## **7.7 Control Systems Not Required for Safety**

The information in this section of the reference ABWR DCD, including all subsections and figures, as modified by the STP Nuclear Operating Company Application to Amend the Design Certification rule for the U.S. Advanced Boiling Water Reactor (ABWR), "ABWR STP Aircraft Impact Assessment (AIA) Amendment Revision 3," dated September 23, 2010 is incorporated by reference with the following departures and supplements.

Figure 7.7-11 Simplified Functional Diagram of the Automatic Power Regulation System

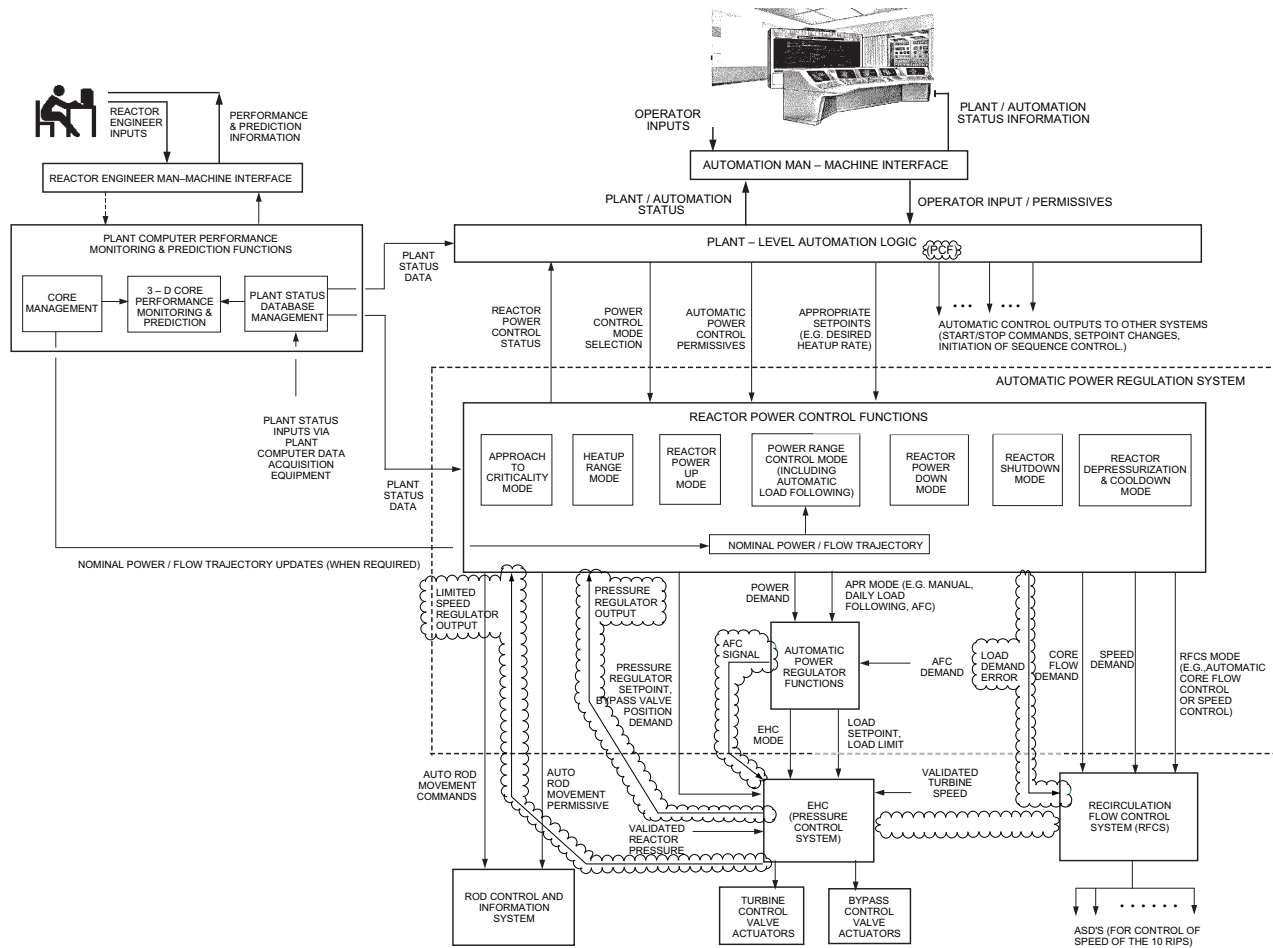
STD DEP T1 3.4-1 (Figures 7.7-2, 7.7-3, 7.7-4, 7.7-5, 7.7-7, 7.7-8, 7.7-9, 7.7-11)

STD DEP 7.7-20 (Figures 7.7-5, 7.7-7, 7.7-11)

STD DEP 7.7-24 (Figures 7.7-11, 7.7-12, 7.7-13)

The primary objective of the Automatic Power Regulator (APR) System is to control reactor power during reactor startup, power generation, and reactor shutdown, by appropriate commands to change rod positions, or to change reactor recirculation flow. The secondary objective of the APR System is to control the pressure regulator setpoint (or turbine bypass valve position) during reactor heatup and depressurization (e.g., to control the reactor cooldown rate). The APR System consists of redundant process controllers. Automatic power regulation is achieved by appropriate control algorithms for different phases of the reactor operation which include approach to criticality, heatup, reactor power increase, automatic load following, reactor power decrease, and reactor depressurization and cooldown. The APR System receives input from the ~~plant computer~~ PCF, the Power Generation Control System (Subsection 7.7.1.5.42), the Steam Bypass and Pressure Control System (Subsection 7.7.1.8), and the operator's control console. The output demand signals from the APR System are to the RCIS to position the control rods, to the RFC System to change reactor coolant recirculation flow, and to the SB&PC System for automatic load following operations. The ~~PGSPGCS~~ performs the overall plant startup, power operation, and shutdown functions. The APR System performs only those functions associated with reactor power changes and with pressure regulator setpoint (or turbine bypass valve position) changes during reactor heatup or depressurization. A simplified functional block diagram of the APR System is provided in Figure 7.7-11.
